SERVICE BULLETIN

TBM AIRCRAFT

SB 70-250

SUBJECT : GTX 345R TRANSPONDER RETROFIT

Figure 1

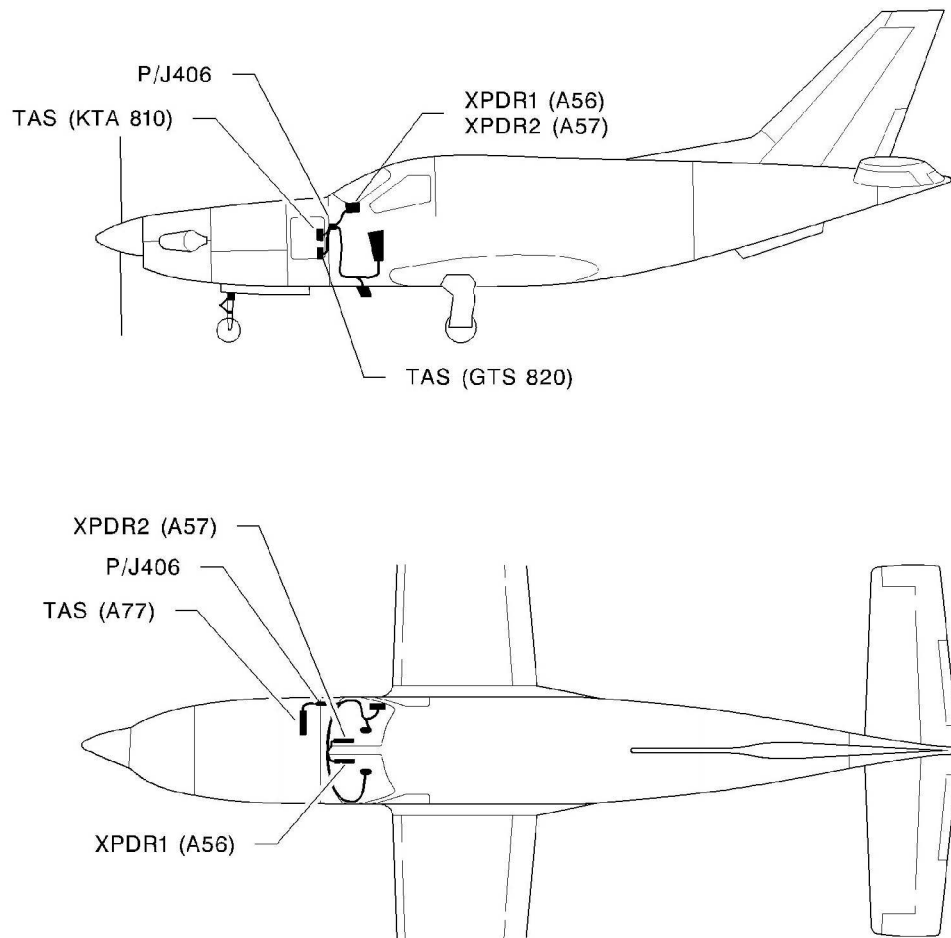
E. PL1 CIRCUIT BREAKER PANEL MODIFICATION – See Figures 1, 2, 3A, 3B, 4A and 5A

- 2) Replace “CB90” circuit breaker – refer to Chapter 24–60–01 page 401 of the Maintenance Manual.

- 2) Replace “CB75” circuit breaker – refer to Chapter 24–60–01 page 401 of the Maintenance Manual.

Figure 3 – TAS KTA 810 Wiring modification – Pre-SB70-250-34

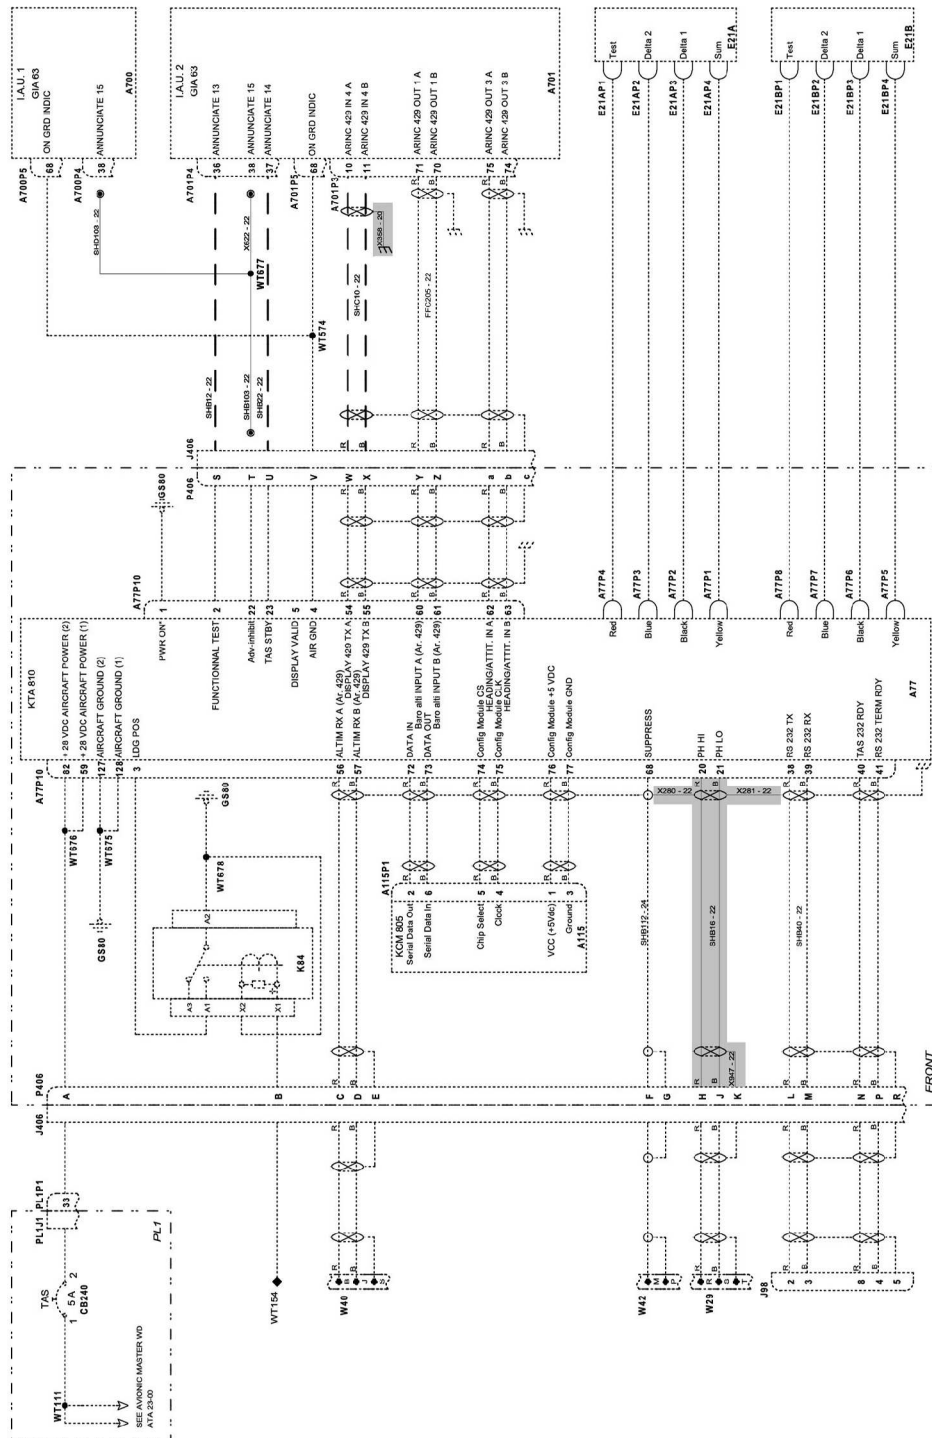
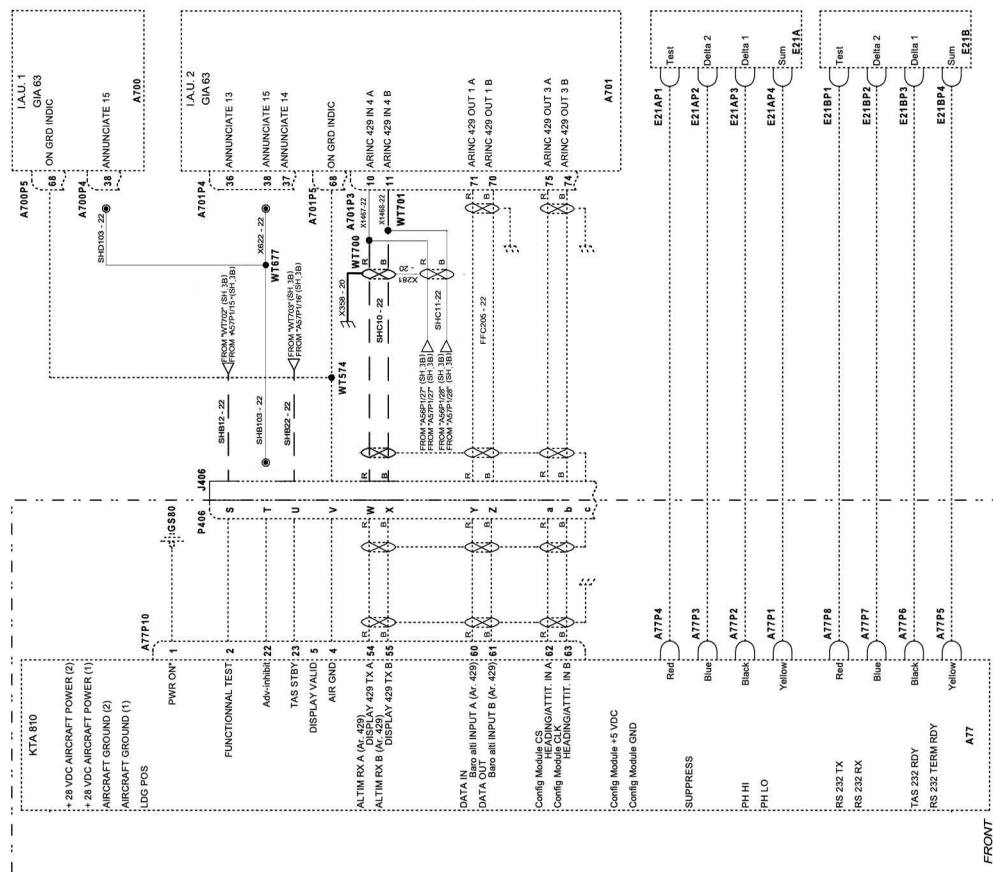
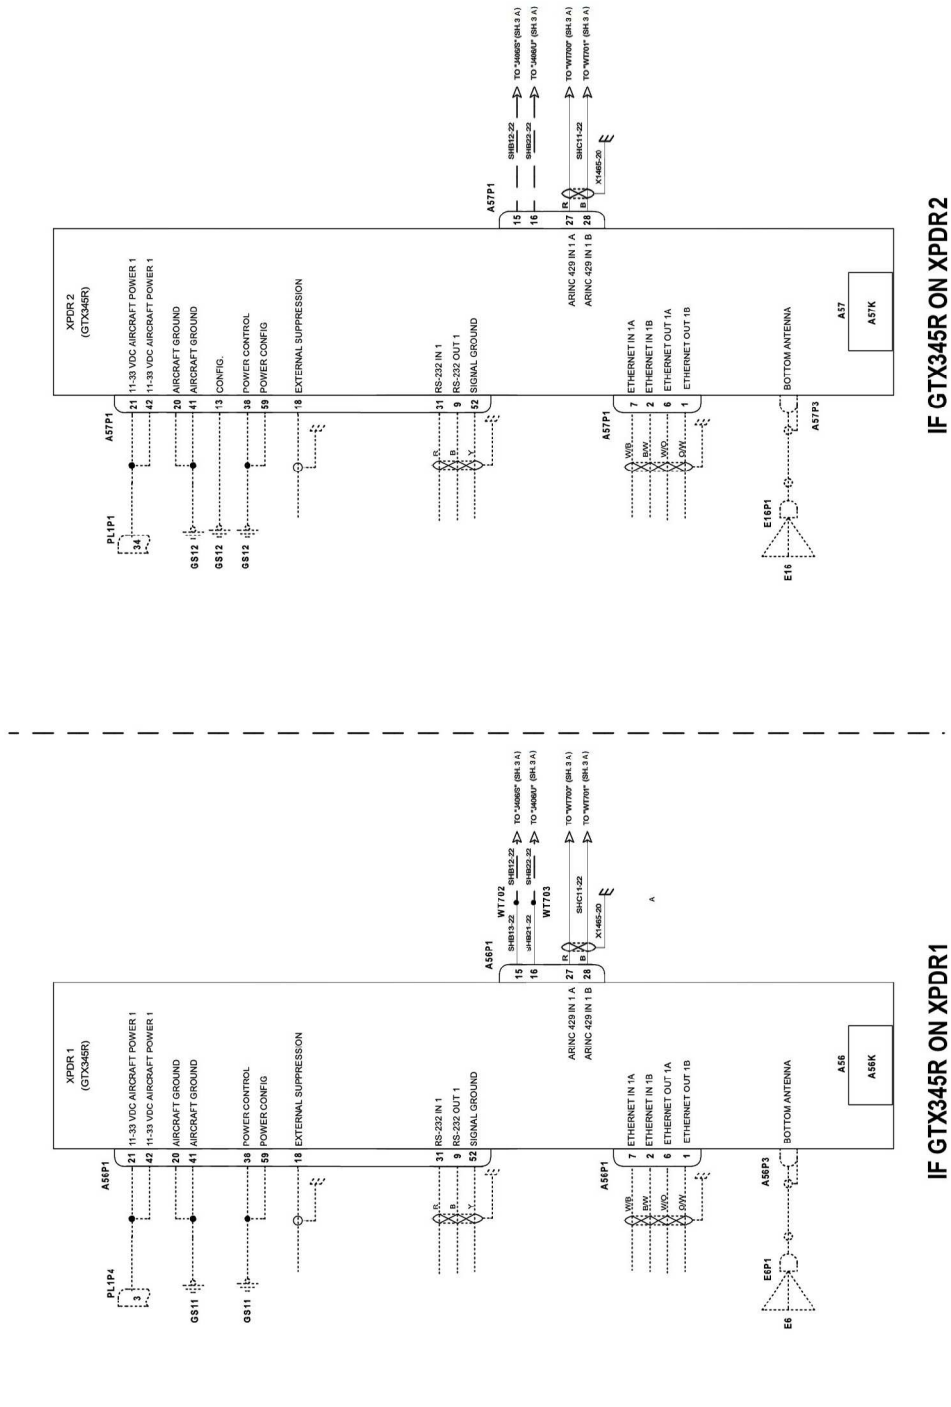
- 13) Set “SOURCE” selector to “OFF” and pull down the crash lever.
 - 14) Remove front seats – refer to Chapters 25–12–01 page 401 and 25–12–02 page 401 of the Maintenance Manual.
 - 15) Remove A4 keyboard – refer to Chapter 34–28–14 page 401 of the Maintenance Manual.
 - 16) Remove PFD1/PFD2 units – refer to Chapter 34–28–10 page 401 of the Maintenance Manual.
 - 17) Remove MFD unit – refer to Chapter 34–28–11 page 401 of the Maintenance Manual.
- B. KTA 810 WIRING MODIFICATION – See Figures 3, 3A and 3B

According to Figure 3 :

- 1) Remove and discard wire SHB16 between connector P406 pin H, J and K and A77P10 connector pins 20 and 21 (Remove X280, X281 and X947).
- 2) Disconnect X358 ground wire from wire SHC10, discard X358 ground wire.

According to Figures 3, 3A and 3B :

- 6) Disconnect wire SHB12 from A701P4 pin 36 (it will be connected later to WT702 splice).
- 7) Disconnect wire SHB22 from A701P4 pin 37 (it will be connected later to WT703 splice).
- 8) Prepare wire P/N EN2267–010A004S at a suitable length. Identify it as “SHB13” and equip one side with a pin contact supplied in GTX 345R kit (the other side will be connected to WT702 splice).
- 9) Prepare wire P/N EN2267–010A004S at a suitable length. Identify it as “SHB21” and equip one side with a pin contact supplied in GTX 345R kit (the other side will be connected to WT703 splice).

- 10) Disconnect wire SHC10 from A701P3 pins 10 and 11 (it will be connected later to WT700 and WT701).
 - 11) Prepare wire P/N EN2714–013B004F at a suitable length. Identify it as “SHC11” and equip one side with a two–pin contact supplied in GTX 345R kit (the other side will be connected to WT700 and WT701 splices).

Figure 4 – GTX 345R Installation (XPDR1) – Pre-SB70-250-34

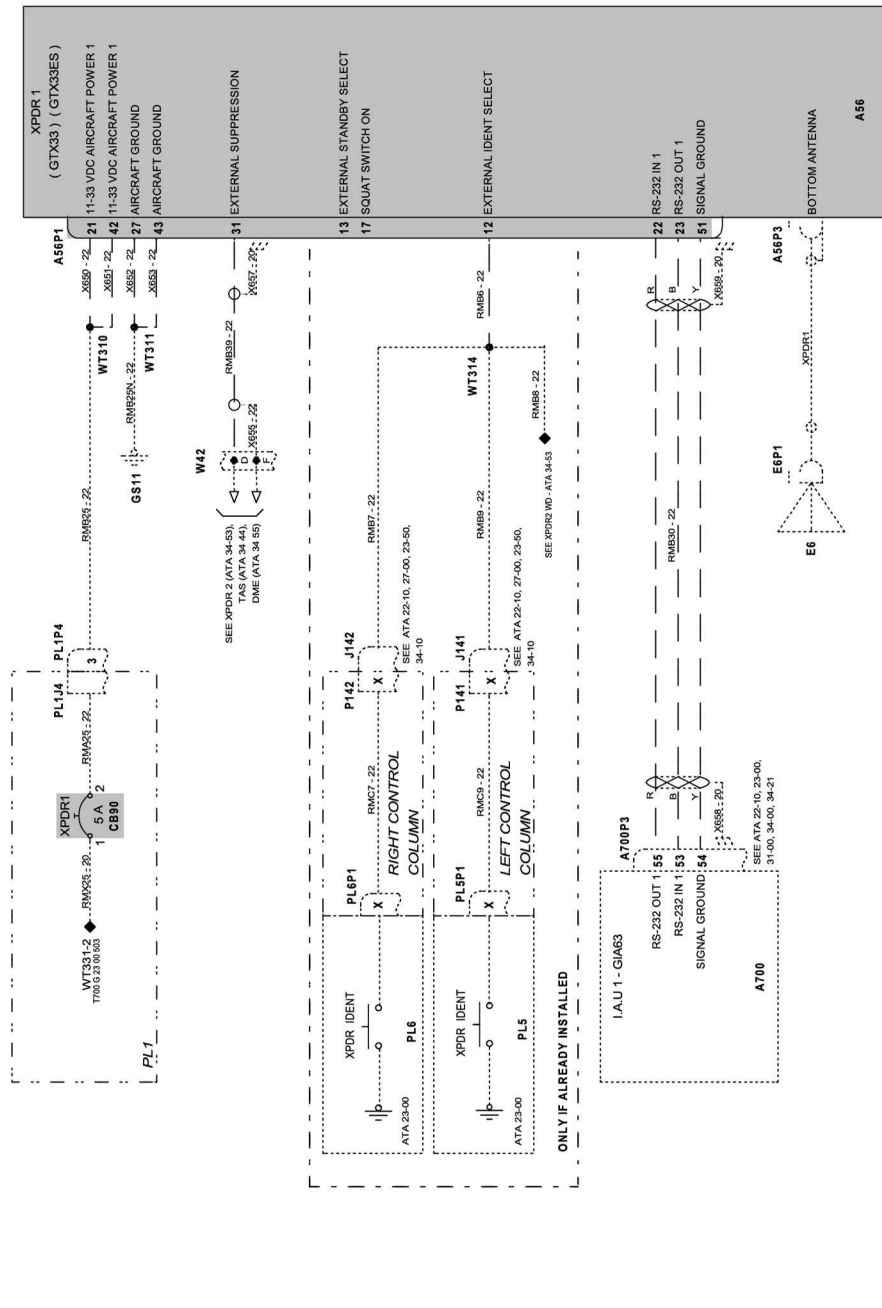
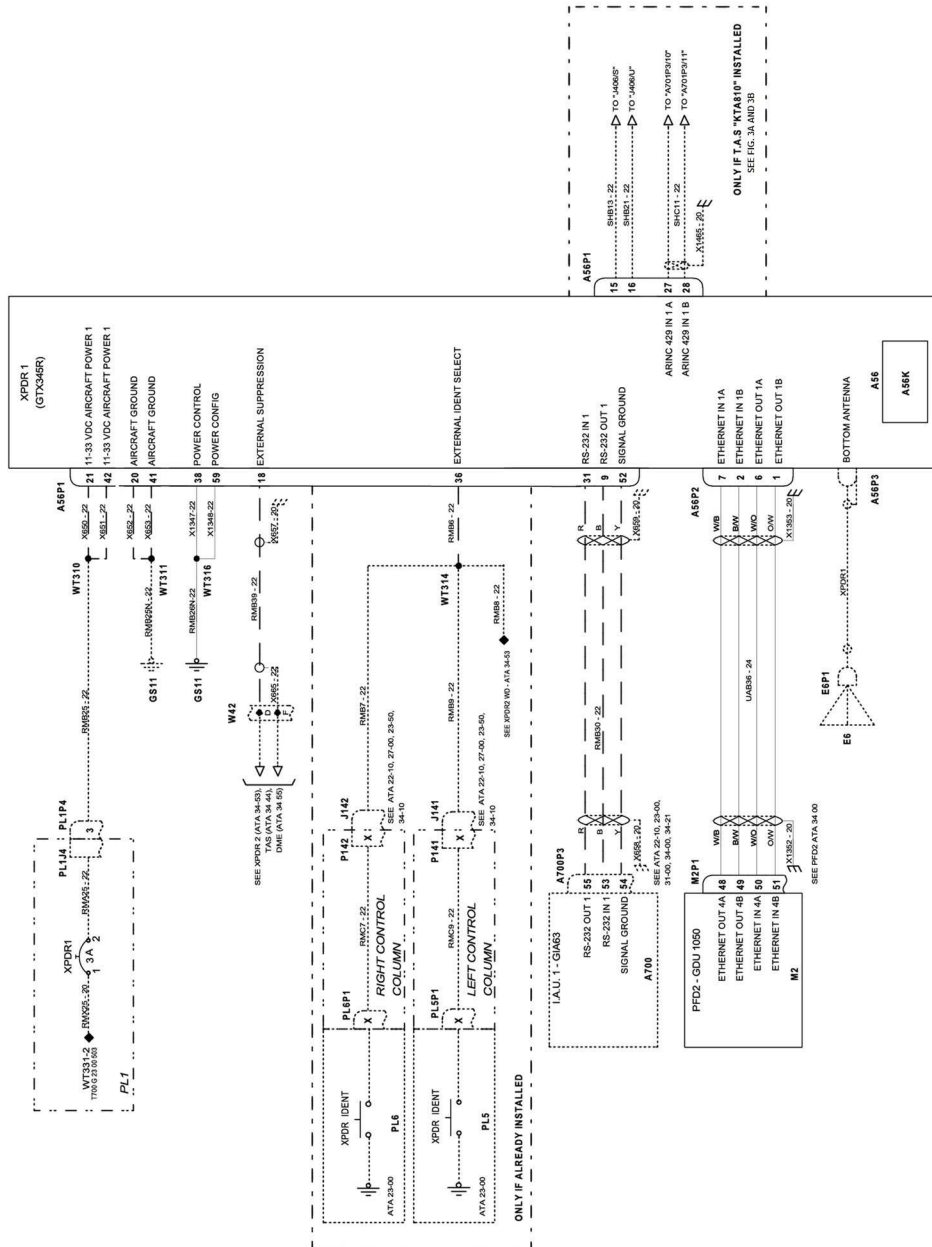
- C. GTX 345R INSTALLATION (TRANSPONDER 1) – See Table 1A and Figures 4 and 4A
- 1) Remove GTX 33 (transponder 1) – refer to Chapter 34–53–01 page 401 of the Maintenance Manual.

- 6) Prepare two wires P/N EN2267–010A006S at a suitable length, X1352 and X1353. Equip one side of each of them with lug NSA936501 TA2003 (the other side will be connected to UAB36 wire).
- 7) Extract all wires from GTX 33(ES) connector and reconnect to GTX 345R connector (Figures 4 and 4A).
- 8) Connect UAB36 between A56P2 and M2-P1.

Figure 5 – GTX 345R Installation (XPDR2) – Pre-SB70-250-34

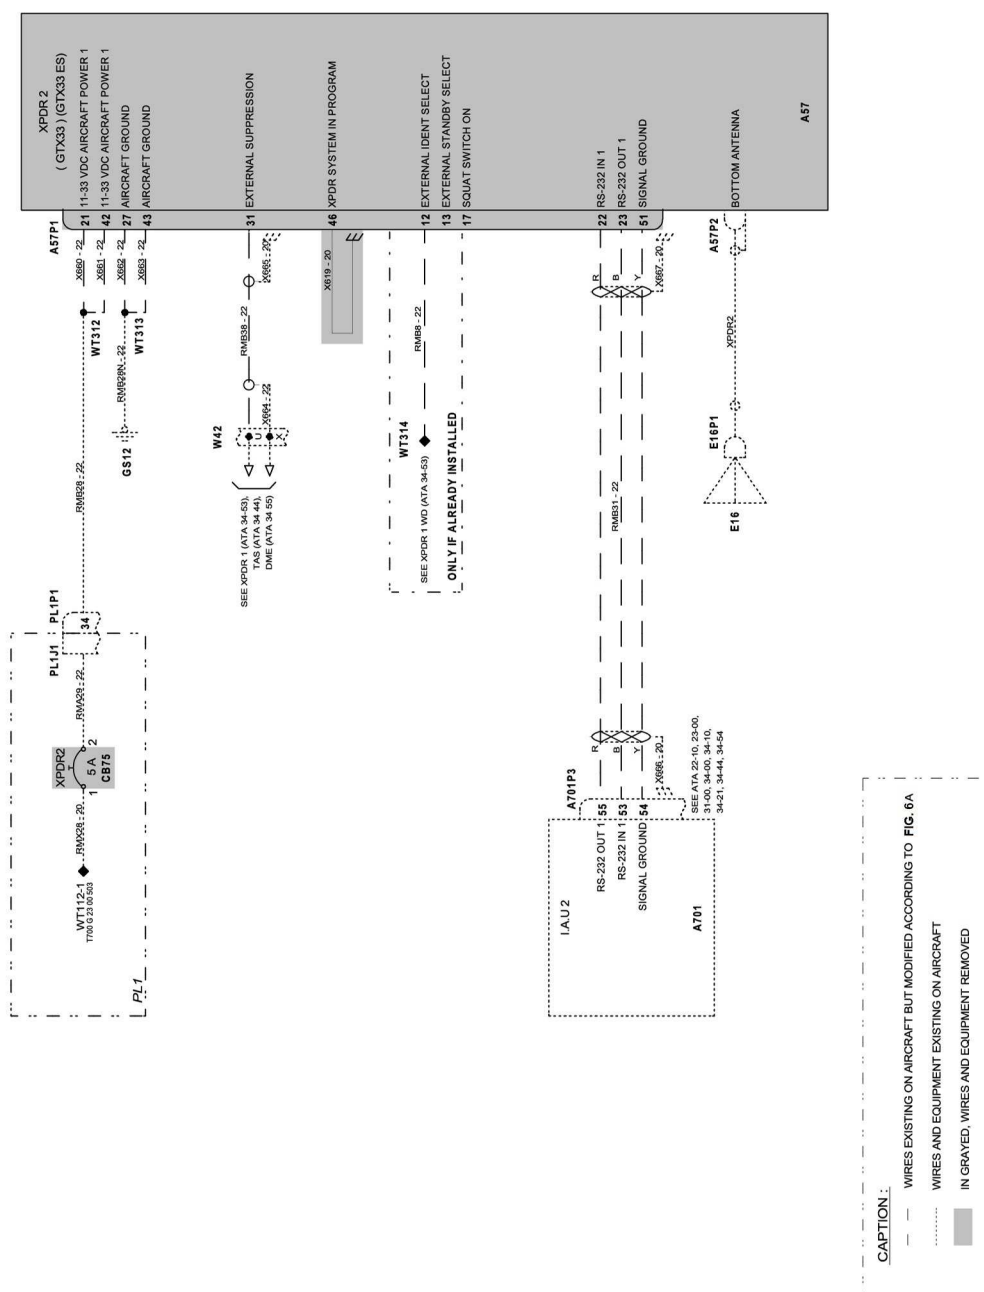
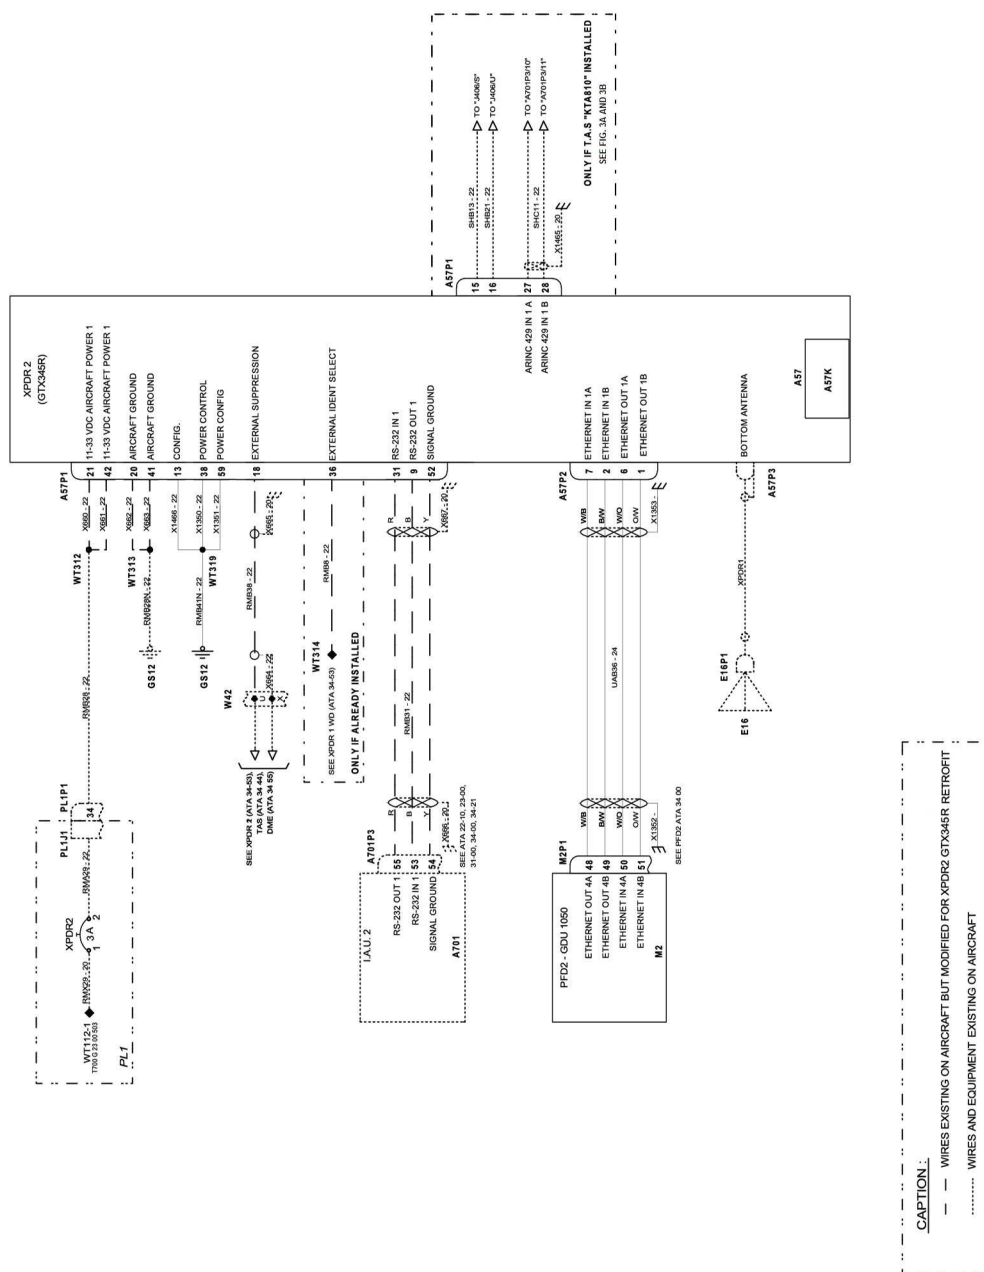
D. GTX 345R INSTALLATION (TRANSPONDER 2) – See Table 1A and Figures 5 and 5A

- 7) Extract all wires from GTX 33(ES) connector and reconnect to GTX 345R connector (Figures 5 and 5A).
- 8) Connect X1350, X1351 and X1466 to WT319 and A57P1 (Figure 5A).
